RESPONSE TO CITY REVIEW COMMENTS

SOUTHWEST VILLAGE SAN DIEGO, CALIFORNIA

**SEPTEMBER 14, 2023
PROJECT NO. 06847-42-04A**

Subject: ADDENDUM REPORT AND RESPONSE TO CITY REVIEW COMMENTS
SOUTHWEST VILLAGE
SAN DIEGO, CALIFORNIA

GEOLOGIC CROSS-SECTIONS			
BEYER BOULEVARD EXTENSION SOUTH OTAY MESA SAN DIEGO, CALIFORNIA			
GEOCON 12400 S.P. AVE. #100 SAN DIEGO, CALIFORNIA 92121 PHONE 619.558.6000 FAX 619.558.6001		SCALE 1" = 20'	DATE 09 - 14 - 2023
PROJECT NO. 06847 - 42 - 05		FIGURE 2	
SHEET 1		OF 1

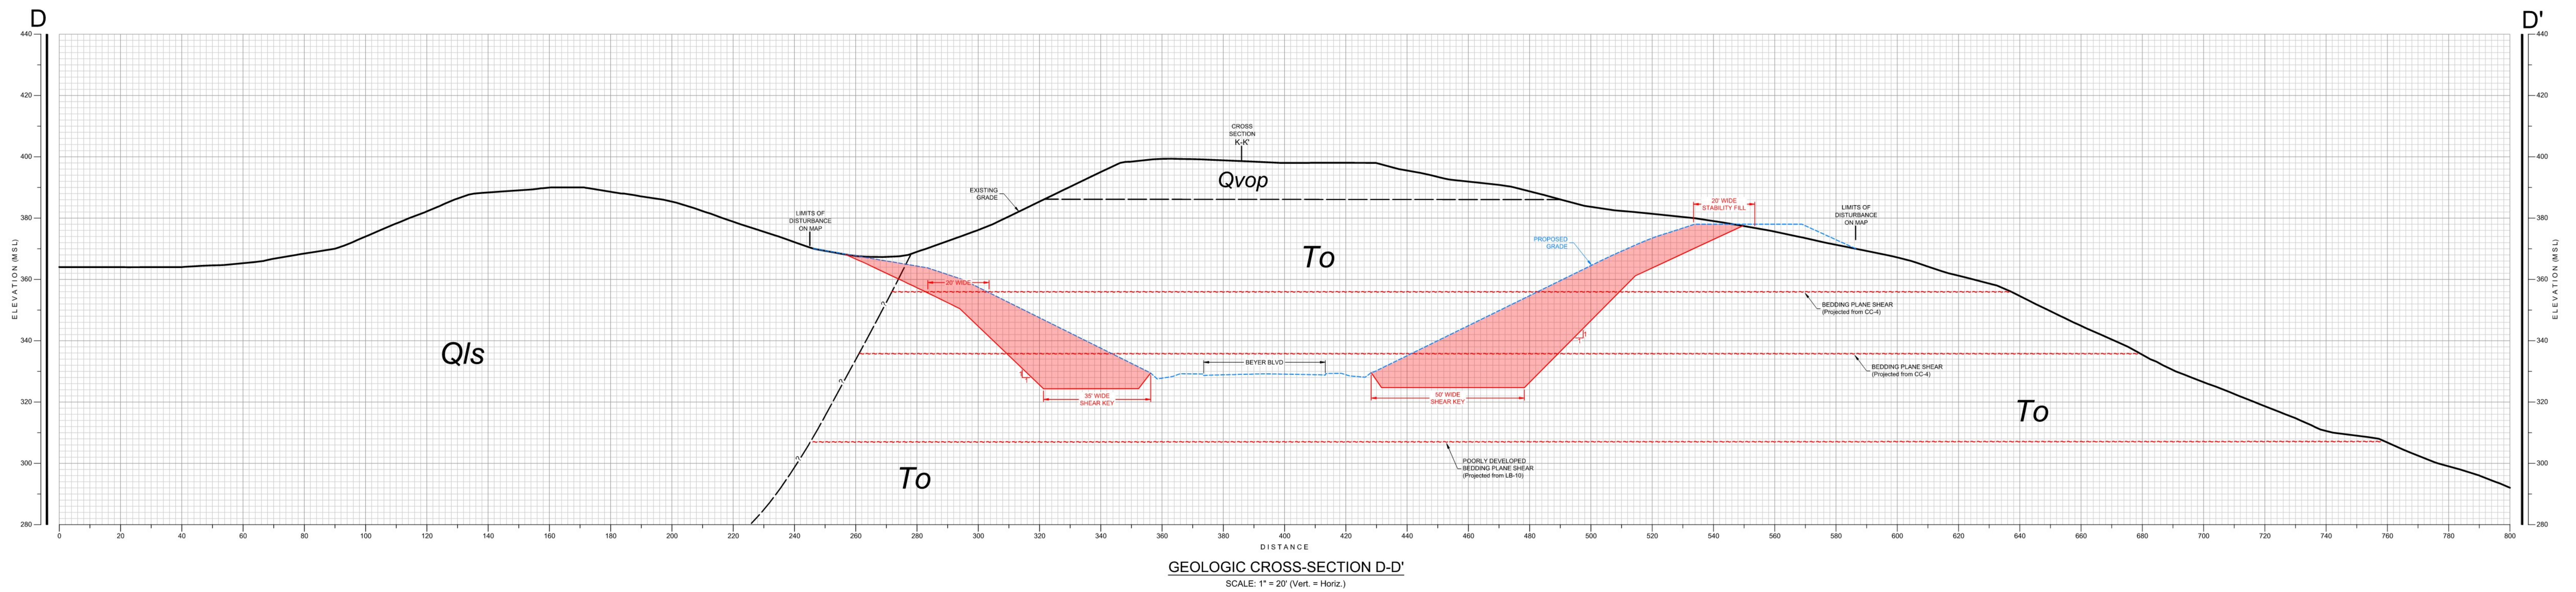
Issue No. 59: *The project's geotechnical consultant indicates in the referenced Response to City Review Comments, dated December 16, 2022, that they have not yet been able to perform the additional study within the County property and that they expect to perform those studies in 2023. Please provide the results from the additional study when they become available.*

The County property is highlighted on the geologic map (Figure 1). Cross section D-D' (Figure 2) represents geologic conditions in the area. The cross section includes proposed grades and buttress construction widths determined from the "worst case" analysis.

To achieve a 1.5 factor of safety under assumed "worst case" conditions, the buttress widths need to be widened approximately 8 feet on the southern cut slope and 15 feet on the northern cut slope from previously designed buttress widths. Figure 2 reflects the increased buttress widths determined for the "worst case" analysis.

The appended figures show the current project disturbance limits. As depicted on Figure 2, grading to construct the buttresses under "worst case" conditions remains within the previously established disturbance limits.
